Millstone Nuclear Power Station, Unit No. 2  
Response to The Request For Additional Information Regarding Resolution of Issues  
Related to Generic Letter 96-06 (TAC No. M96833)

Millstone Nuclear Power Station, Unit No. 2  
Response to The Request for Additional Information Regarding Resolution of  
Issues Related to Generic Letter 96-06 (TAC No. M96833)

**RESPONSE TO REQUEST FOR ADDITIONAL INFORMATION ON GL 96-06  
Millstone Nuclear Power Station Unit No. 2**

FIGURE 1: RBCCW SYSTEM HEADER A SCHEMATIC

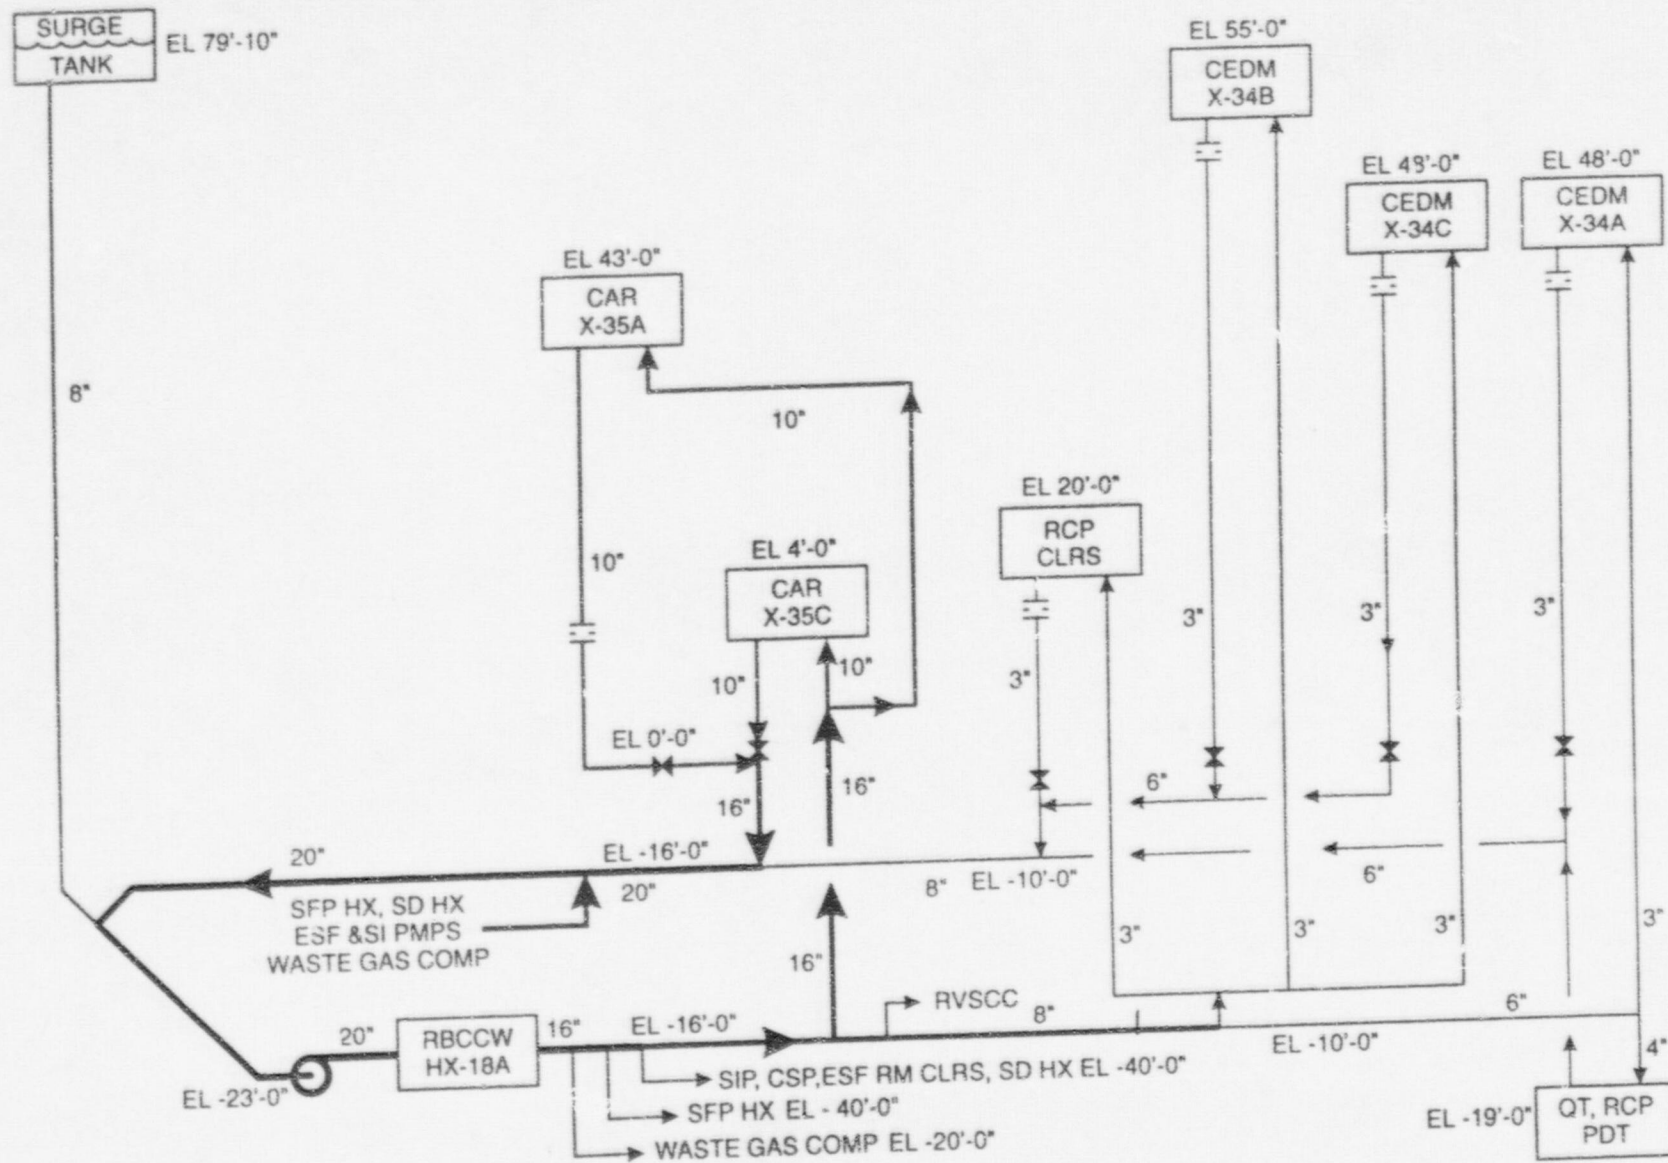
- 5. Provide a simplified diagram of the system, showing major components, active components, relative elevations, lengths of piping runs, and the location of any orifices and flow restrictions.**

Figures 1 and 2 provide simplified diagrams of the RBCCW system Header A and Header B, respectively. These figures show the major components and their relative elevations. Each of the CAR and CEDM unit loops are equipped with a flow orifice and a valve which is throttled for flow balancing purposes. The piping lengths for various portions of the system and the relative locations of these flow orifices and throttled valves are summarized below.

Header A

<u>Description</u>	<u>Pipe Length (ft)</u>	<u>General Information</u>
Surge Line	210	-
Surge Line to Pump	60	-
Pump to RBCCW Hx	70	-
RBCCW Hx to CAR Supply	80	Flow divides to CARs & CEDMs
To CAR X-35A/X-35C Tee	150	Flow divides to X-35A & X-35C
Supply to CAR Inlet	200	-
CAR Outlet to Flow Orifice	250	Flow Orifices at 6.5' & 3.5' Elevations
Flow Orifice to Throttle Valves	18	Throttle Valves at 0.0' Elevations
Throttle Valves to Return Line	80	Flow from CARs Combine
To CEDM X-34A,B,C Tees	200	Flow divides to X-34A,B,C
Supply to CEDM Inlet	100	-
CEDM Outlet to Flow Orifice	25	Flow Orifices at 47', 49' & 48' Elevations
Flow Orifice to Throttle Valves	105	Throttle Valves at 1' Elevations
Valves to CEDM Return Lines	10	-
To CAR Return Line	145	-
From CAP. Return to Surge Line	80	-
